RECEIPT DATE: 5/12/15 **ONSITE SEWAGE DISPOSAL SYSTEM** P 556457

PROPERTY ADDRESS: 2508 Goose Chase Way

RE: BAT Site Plan comments; 2508 Goose Chase Way (Cloverfield II, Lot 7)

SITE PLAN AND PLOT PLAN FOR BAT INSTALLATION
SPRING MILL LLC
2508 GOOSE CHASE WAY
TAX ACCOUNT NO.: 353427
LOT 7
CLOVERFIELD- SECTION II
3RD ELECTION DISTRICT • HOWARD COUNTY, MD.
TAX MAP: 15 BLOCK: 7 PARCEL: 119

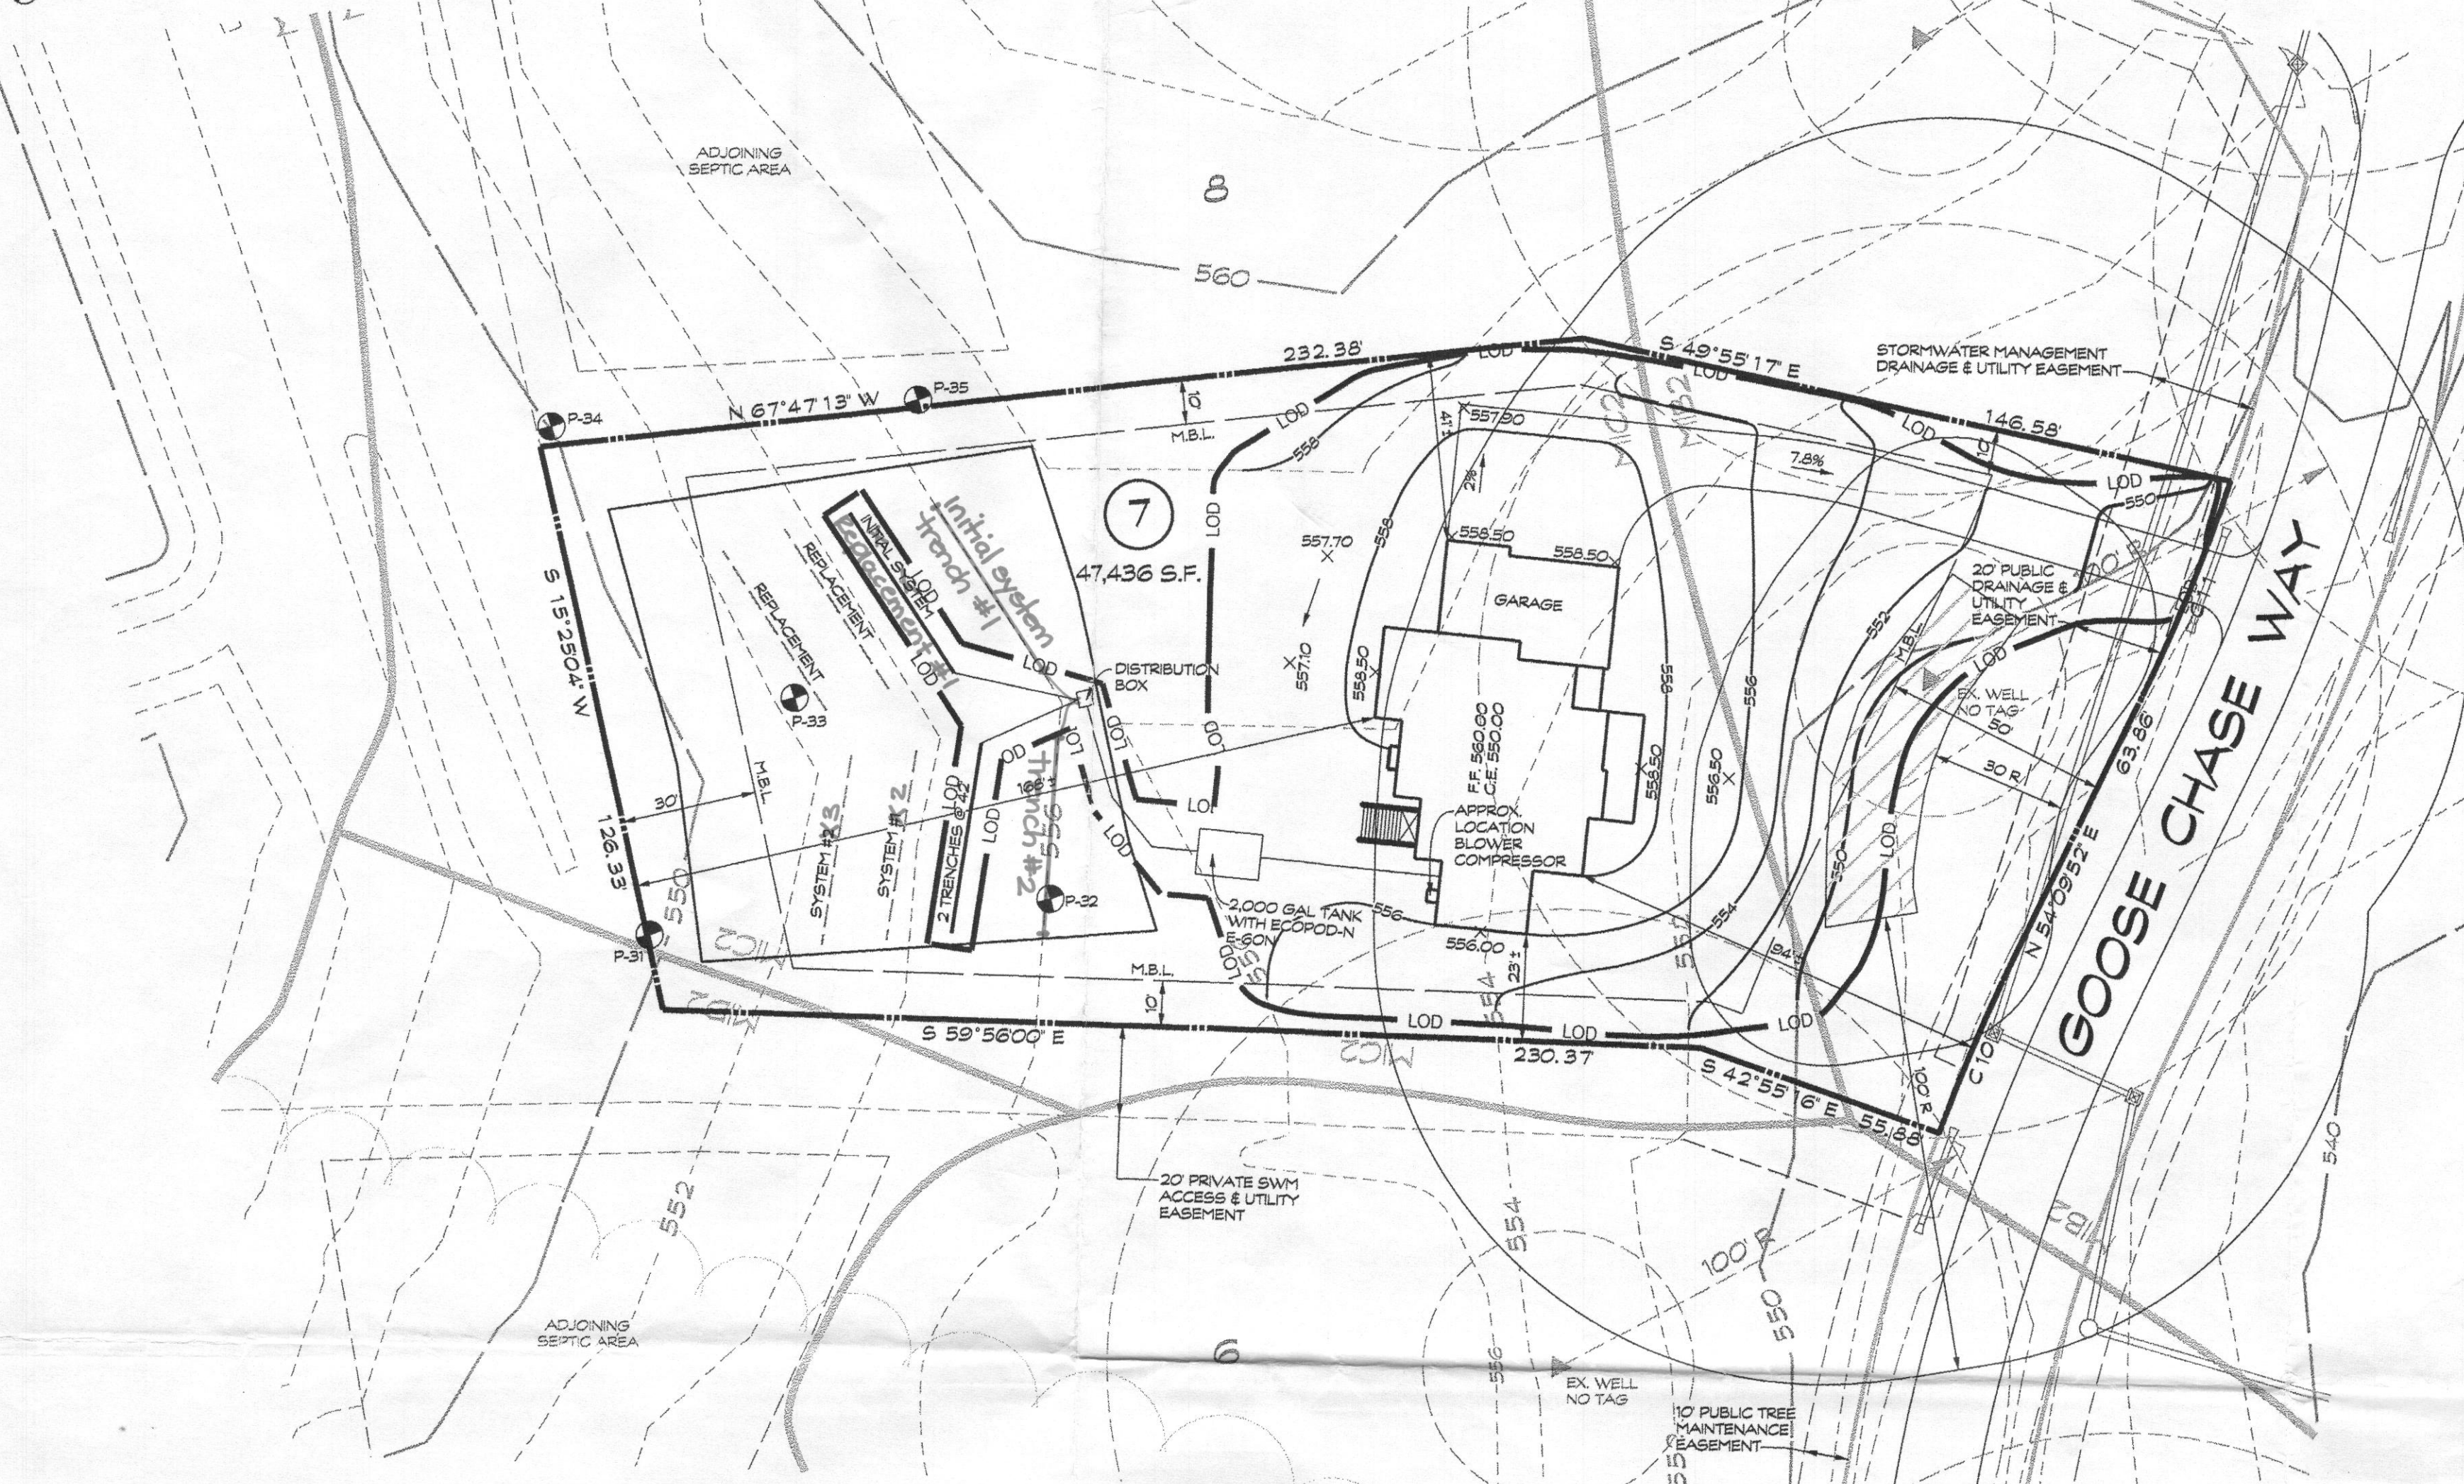
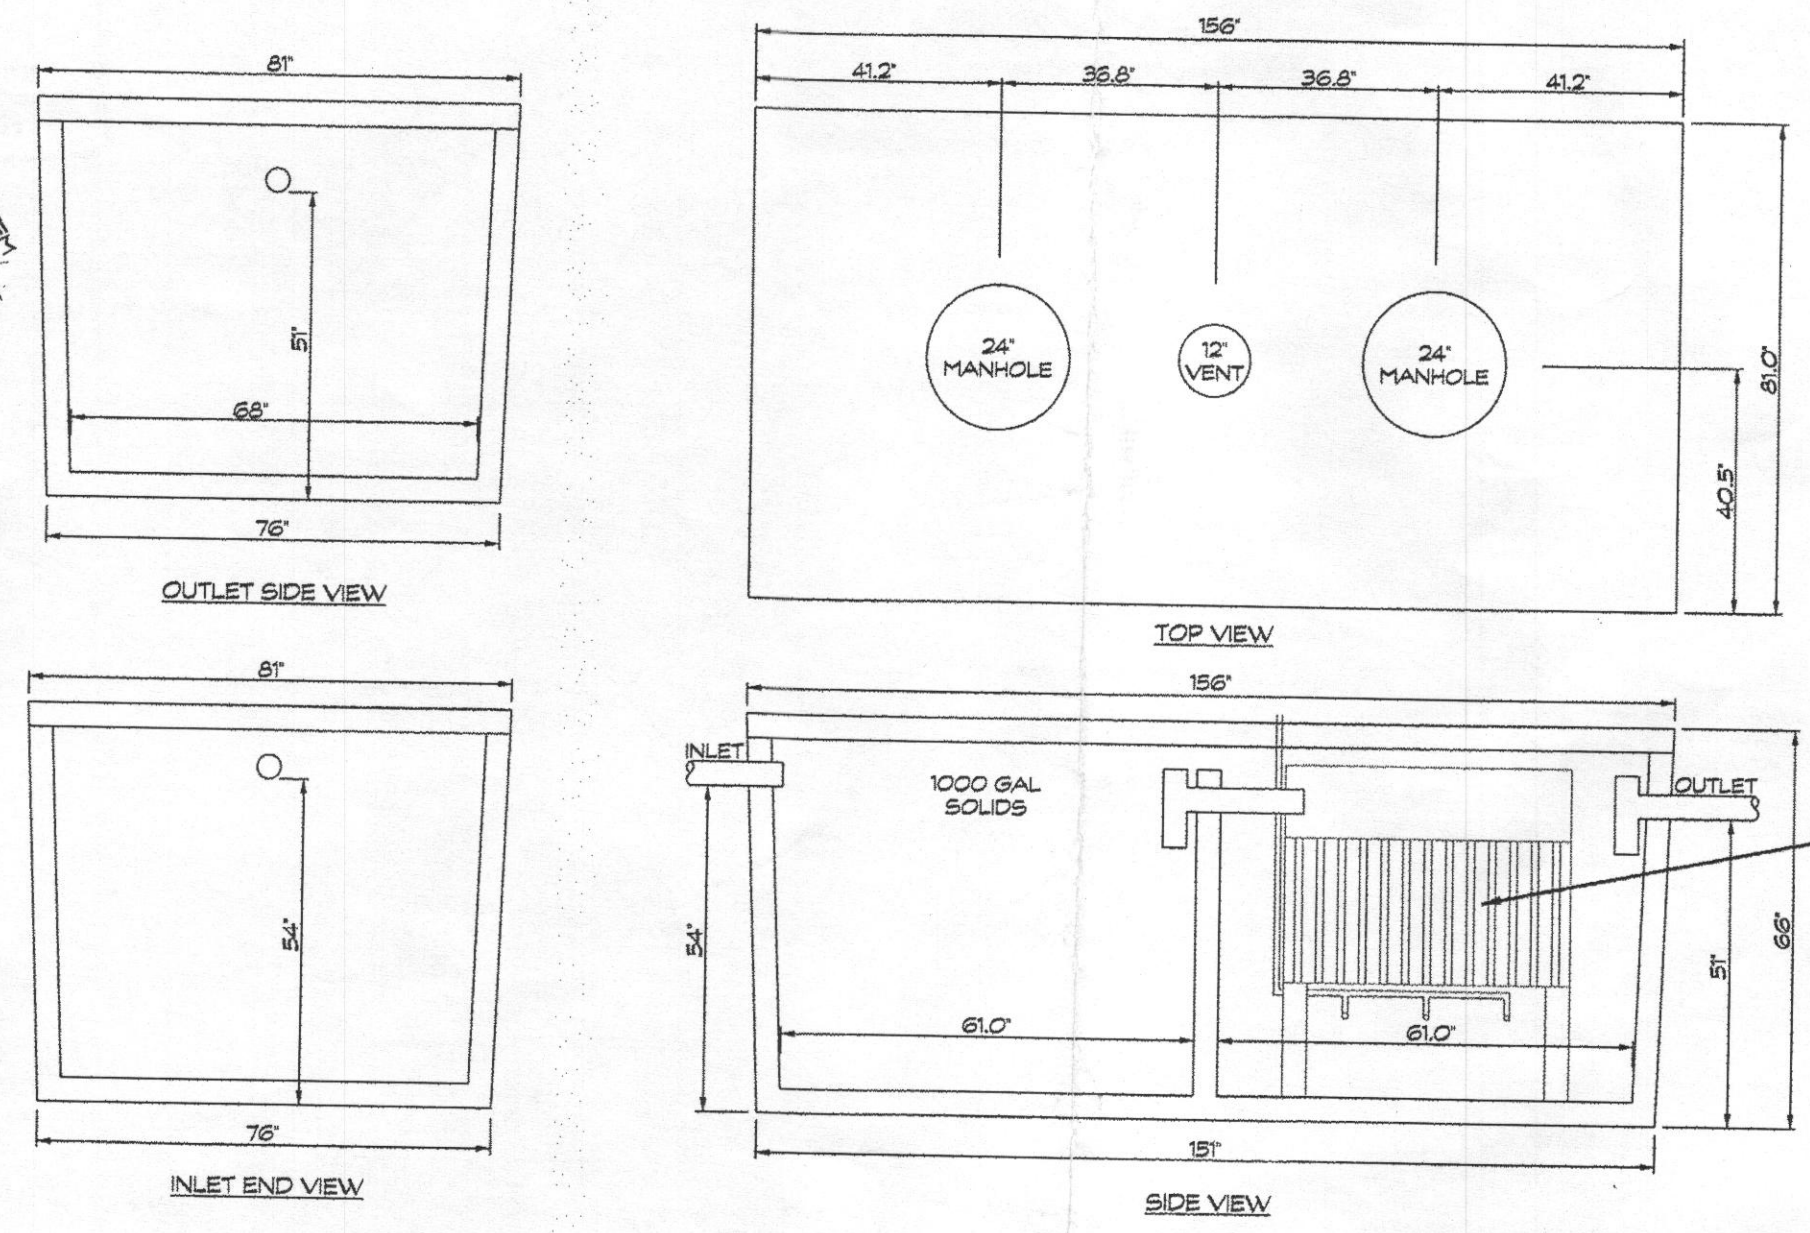
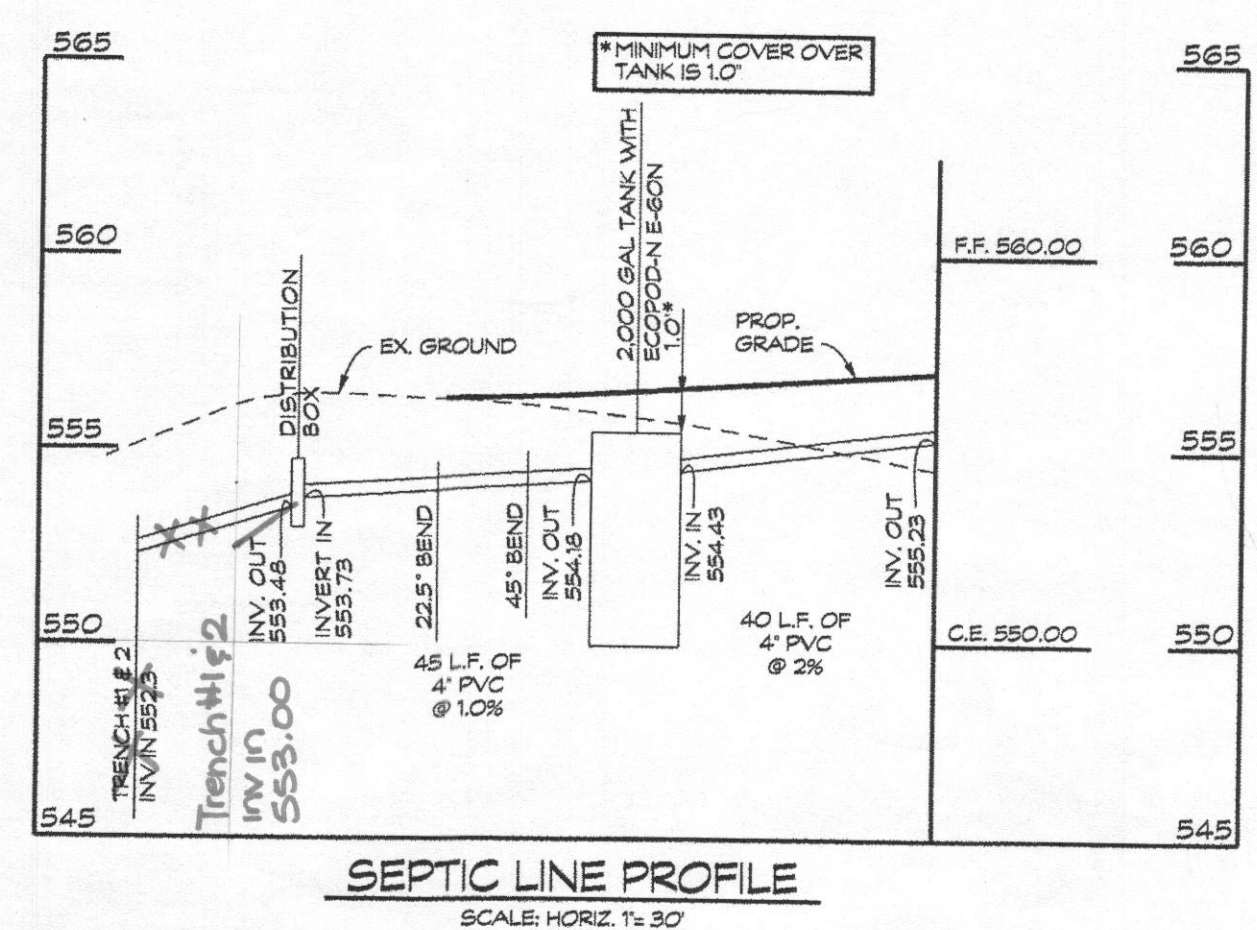
Revisions are needed on the submitted BAT Plan (March 26) for the subject property.

The required revisions are the same as those items which were red-lined on February 6, on the plan proposing an ECOPOD installation. See the three (3) pages attached which are photocopies of the portions of the plan red-lined on February 6.

1. The well configuration on the referenced Percolation Certification Plan (October 2007) is a well zone. The configuration of three well locations illustrated on this submittal is not approvable without a revised Percolation Certification Plan.
2. The areaway is considered part of the foundation, therefore the BAT unit must be at least 20 feet from the areaway.
3. The distribution lines are spanning a concave landform, and your placement of trenches utilizes the sewage disposal area in a very inefficient manner. The best option to mitigate these issues is to place a distribution box at the uppermost boundary of the sewage disposal area and illustrate equal length lines to each side of the swale.
 - a. Limit the trench bottom to 5.5 feet. (Please notice that this reduces your coefficient for trench length reduction = 0.5)
 - b. Utilize 42-foot trenches to either side of the D-Box

1. The plan has been revised per the attached red lines.
